Field campaign

Topic	15MY power boot PDI check (SC15/05)
Market area	Bentley: worldwide (2WBE)
Brand	Bentley
Transaction No.	2039914/2
Campaign number	EA26
Note	
Type	Campaign before delivery
US code

15 MY Continental

Figure 1

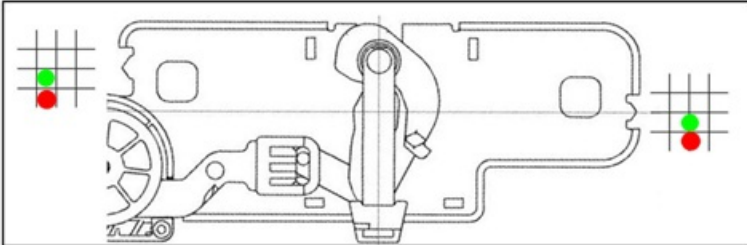
4. Record the position, using attached strikerlatchmarkup.pdf, of the powered striker in relation to the grid stamped into the rear panel (see Figure 1 for example)

5. Mark the starting position of the striker, red dots in example, and then slacken the fasteners securing the striker
6. Adjust the striker vertically upwards in half square increments in reference to the grid lines, tighten the fasteners and re test. Continue adjustment until 3 successful boot latching cycles are observed. Note: The striker plate should be adjusted equally so as to remain horizontal

7. Record the final position of the striker on the grid, green dots in example.
8. Finally torque tighten striker fasteners 20 Nm
9. Refit the boot sill finisher cover. "Refer to Boot aperture finishers - To remove and fit" Rep.Gr.70.
